# UNITED STATES PATENT AND TRADEMARK OFFICE

**Office Action Summary**

10/735,446

### **DETAILED ACTION**

FIGURE 1E: Examiner's Figure of the More reference

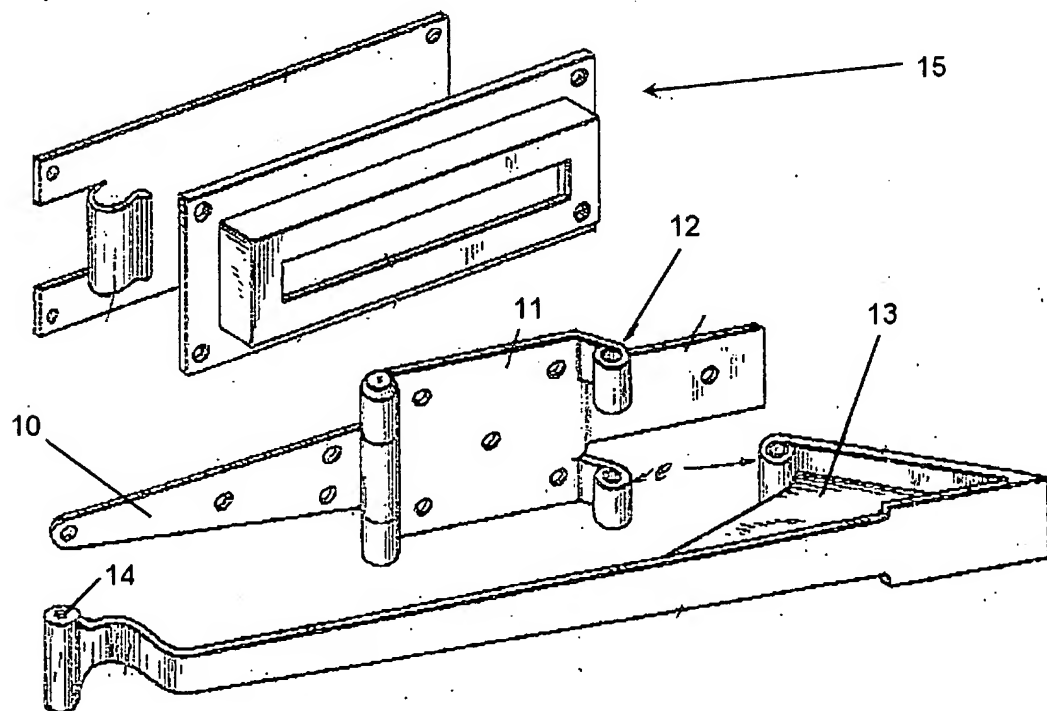
Claims 1, 10, and 30-32 are rejected under 35 U.S.C. 102(b) as being anticipated by US Patent No. 1,898,562 to More (Please see Examiner's Figure 1E below for reference).

In regard to claims 1 and 10 More discloses a door hinge fixture comprising: a first plate 10 having a surface for receiving a component (door); a second plate 11 having a surface for attachment to a frame or rack and cooperating with the first plate to

form a combination of mounting plates, and a flange 12 extending from a longitudinal edge of the surface of the second plate; wherein the first plate is pivotally connected to the second plate so that, in a first position, the first plate is adjacent to and in substantial alignment with the second plate and, in a second position, the first plate is rotated to an orientation which longitudinally projects from the second plate; and a locking mechanism 13 fixed to the flange of the second plate, wherein the locking mechanism includes a tip 14 which is movably coupled with the flange of the second plate for selectively engaging the component received by the first plate, wherein said tip is capable of being manually retracted.

In regard to claims 30-32, More further discloses a bracket 15 for association with the component received by the first plate and spaced from the hinge fixture, for selective engagement by the tip of the locking mechanism.

With respect to the rejections based on US Patent No. 1,898,562 to More (More), the Applicant recites, "there is no disclosure by More of a manually retractable locking mechanism which is movably coupled with the flange that receives it" (see Remarks, pg. 13, lines 23-25). On the contrary, More discloses a latch that is hingedly, and therefore movably coupled to the flange that it hinges with.

The lock mechanism (a), which includes tip (i) (see FIG. 4), meets the claim limitation "manually retractable." Because the limitation "manually retractable" is based on use by an individual, a reference need only be capable of being manually retracted, and need not be explicitly shown as being manually retracted. The applicant asserts, "manual engagement of the pin (i) is precluded" (Remarks, pg. 14, lines 15-16). However, tip (i) is formed as a unitary portion of member (a), which is inherently capable of being grasped and pushed in the direction of the closing door, thereby retracting the tip.

The Applicant further recites, "More also does not disclose 'a flange extending from a longitudinal edge of the surface of the second plate' . . . but rather positions the hinged connection e along a lateral edge of the hinge plate d . . . ." (see Remarks, pg. 14, lines 2-5). The terms "longitudinal" and "lateral" depend on the orientation of the device disclosed by More, as well as the present invention. It is well within the scope of the invention of More to position said device so as to support a door, window, or the like at any angle or orientation. Thus, depending on said orientation, what may be considered an edge extending in a "longitudinal" direction by one may be considered as extending in a "lateral" direction by another.

The Applicant further recites, "More also does not disclose "selective engagement of the component received by the first plate" (Remarks, pg. 14, lines 7-8). The limitation "to selectively engage the component received by the first plate" (claims 1 and 10) is interpreted to mean that tip is capable of being in an engaged position relative to the component, as well has a disengaged position. In More, the component is a door, including plate (m) attached thereto, and adapted to receive the tip (i) in its curved latch member (n) (analogous to the bracket 36 of the present invention shown in Figure 6). As shown in Figure 2 of More, the tip is in an engaged position with the door, because it holds the door in a locked, open orientation. When the tip is retracted (manually or otherwise) from the latch portion (n), the door returns to the orientation shown in Figure 1, disengaged from the tip (i). The fact that the device of More has a keeper to guide the motion of tip (i) does not detract from the fact that the tip engages the component in a first position (Figure 2), and disengages the component in a second position (Figure 1). It is further noted that the width of the keeper (j) relative to that of the tip (i) shown in Figure 2 of More indicates that the tip and arm assembly (a) are capable of being completely out of contact with the keeper, as well as the door and plate (m).
